Halton District School Board

Addendum No. 4

RFT 26-030 Oakville #5 Elementary School & Child Care Facility

ADDENDUM NO. 4**Issued February 10, 2026**

1 STAIR A - GROUND FLOOR
SCALE: 1:50

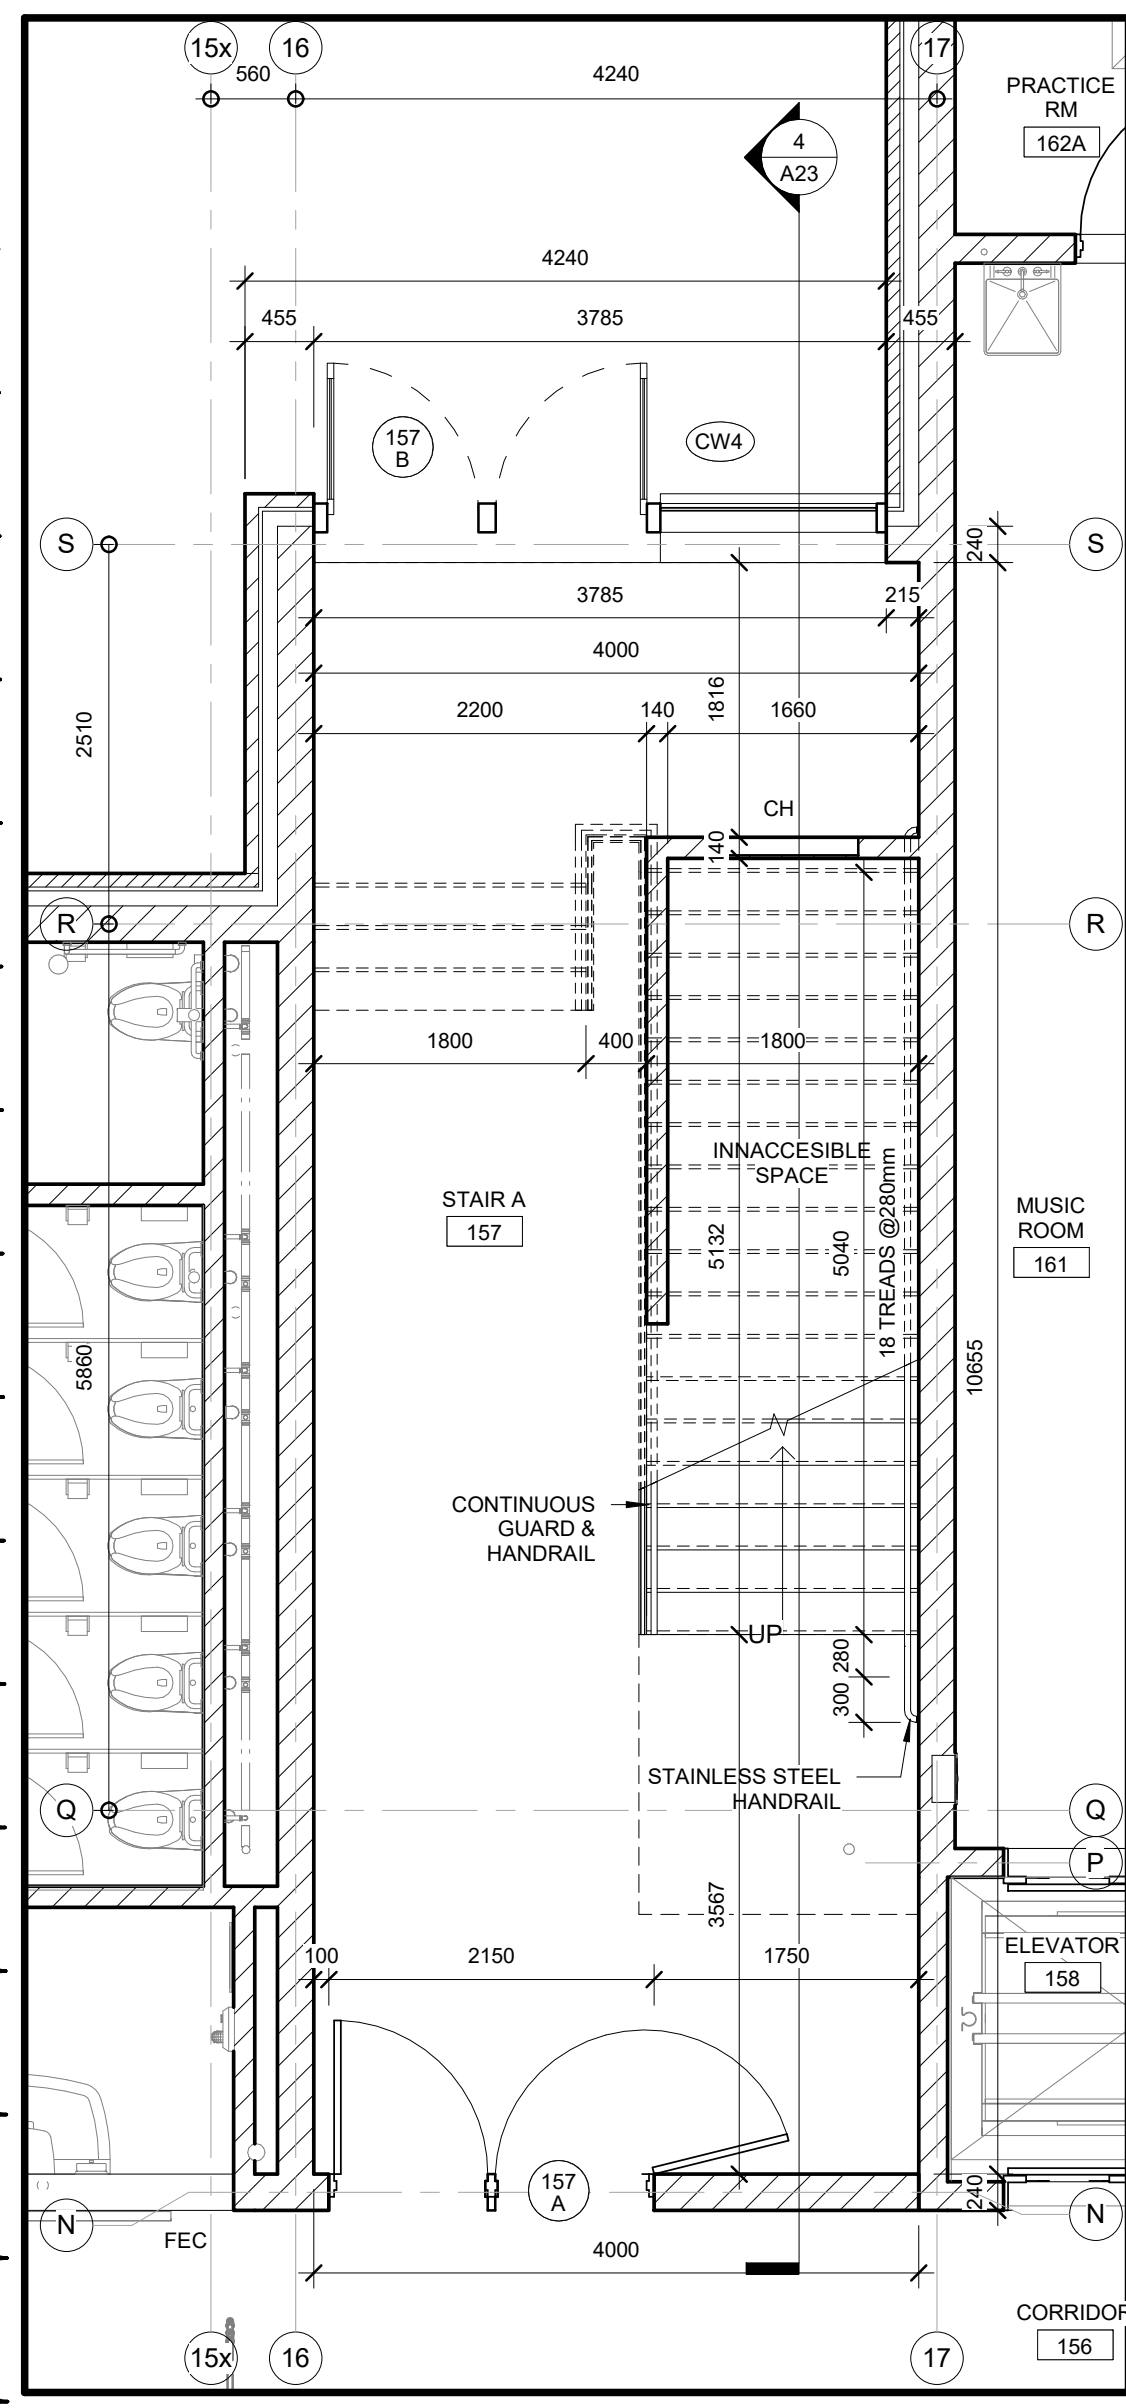
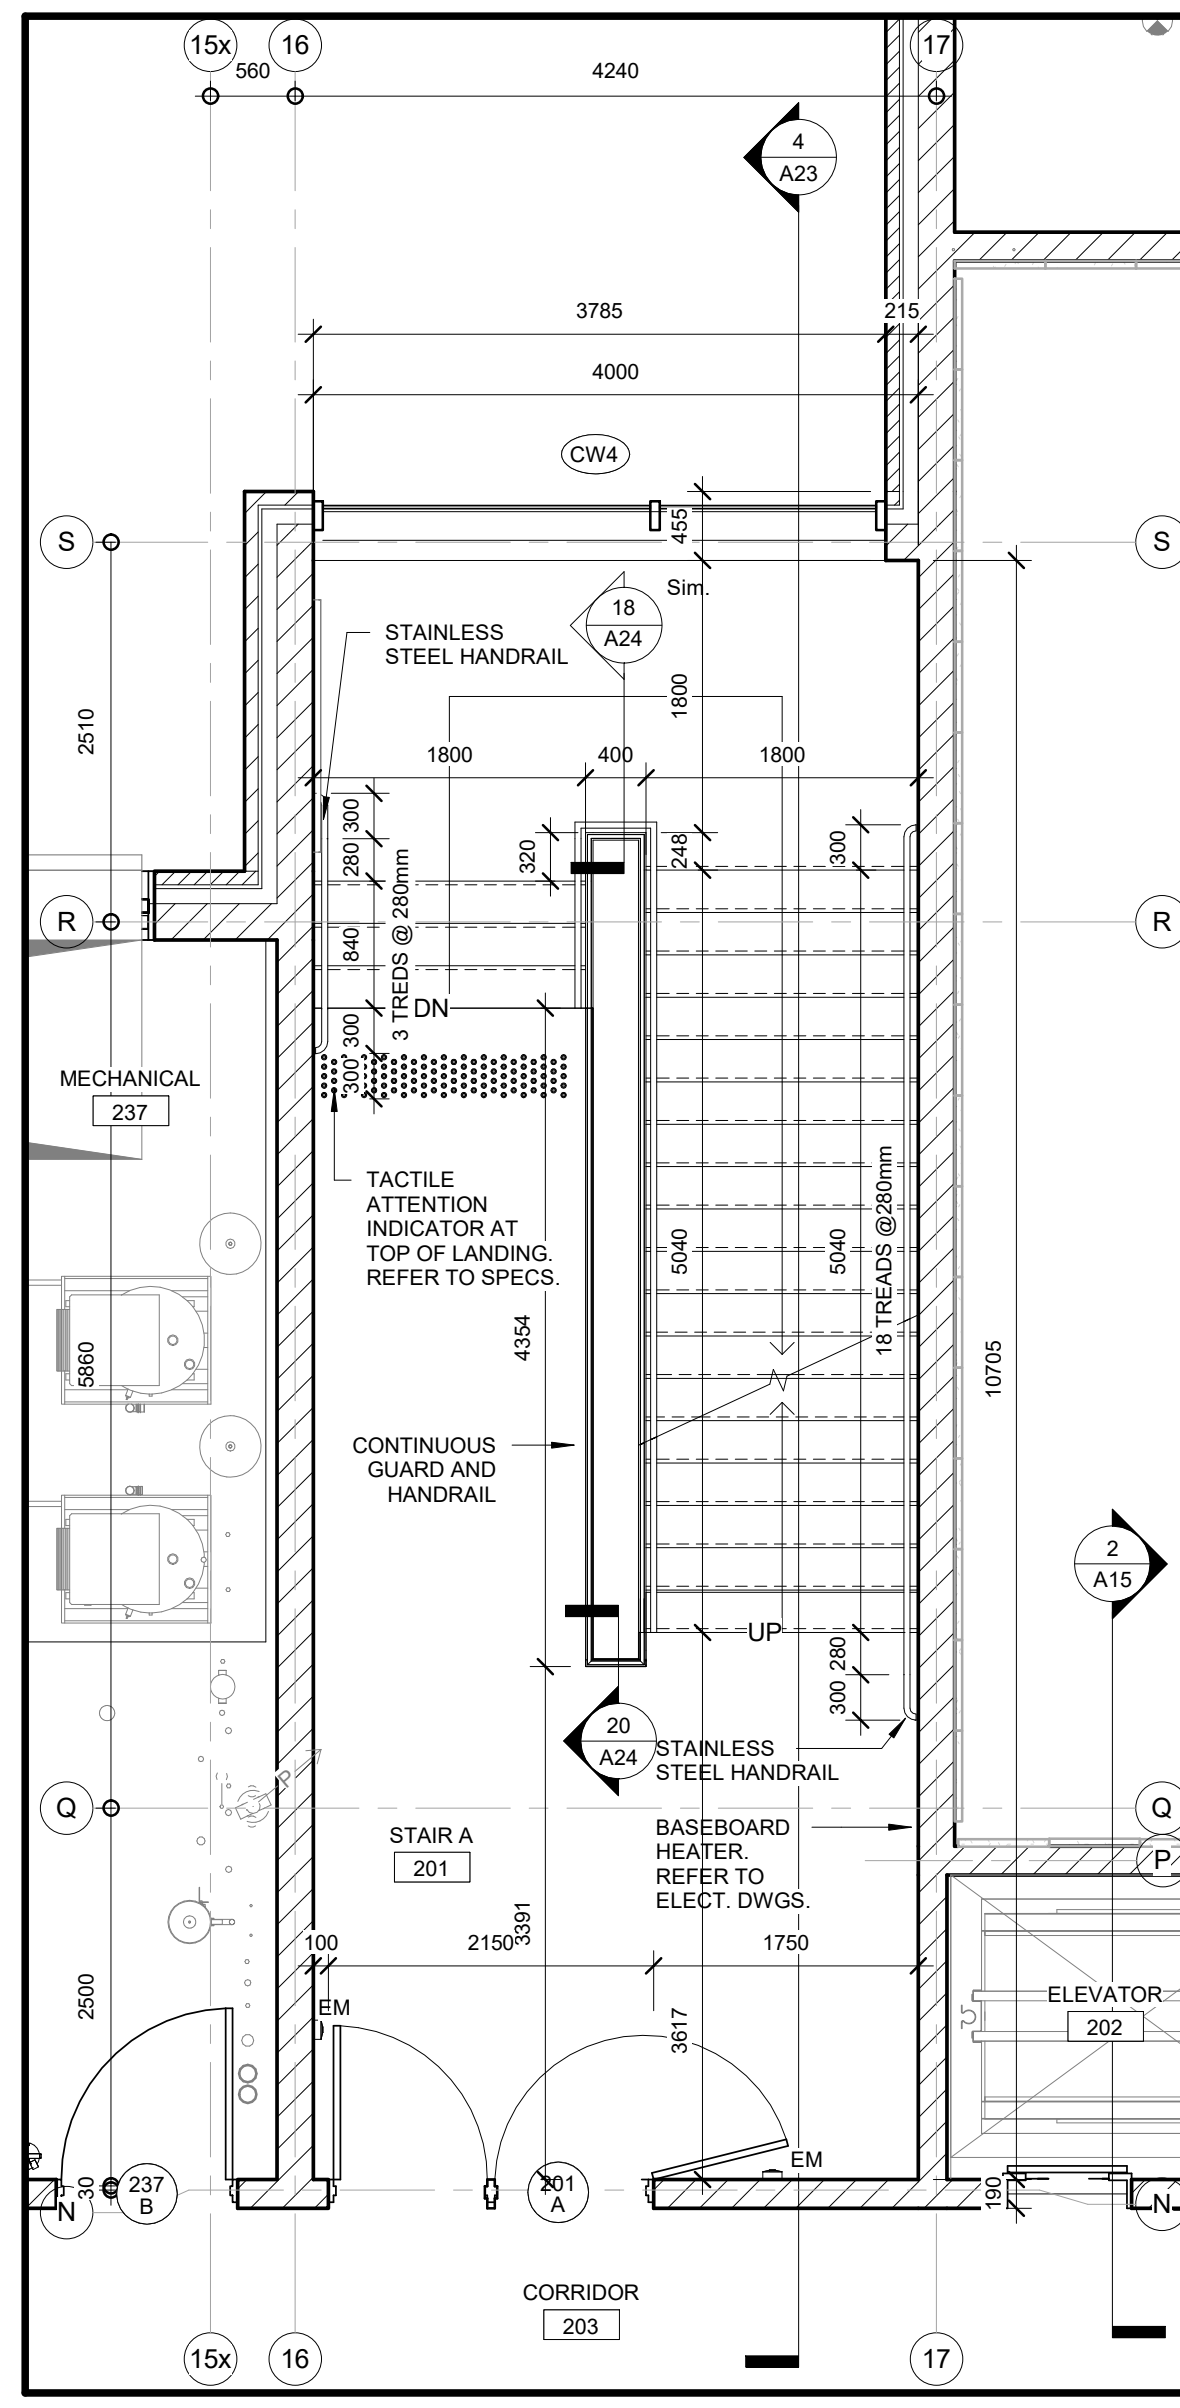
- .1 REPLACE: screen tag 'SC2' in General Office 103 with 'SC6.'
- .2 REVISE: layout of 'STAIR A 157' per enclosed drawing 'A02', dated February 5, 2026.
- .3 ADD: 'BFP' at door 422B per enclosed drawing 'A02', dated February 5, 2026.
- .4 ADD: 'CR+S' in STAFF LOUNGE 111 per enclosed drawing 'A02', dated February 5, 2026.

- .1 REVISE: layout of 'STAIR A 201' and per enclosed drawing 'A03', dated February 5, 2026.
- .2 REVISE: text at high block wall along gridline '8' between gridlines 'E' and 'F' to read, "2200 mm HIGH BLOCK WALL. WITH DOUBLE BULLNOSE BLOCK AT TOP AND EDGE."
- .3 ADD: text 'BB FULL WALL' in QUIET ROOM 231, QUIET ROOM 229, QUIET ROOM 240, QUIET ROOM 245 and QUIET ROOM 248, per enclosed drawing 'A03', dated February 5, 2026.
- .4 REVISE: location of interior door 241A, 242A, 246A and 247A as noted on revised dimension strings, per enclosed drawing 'A03', dated February 5, 2026.
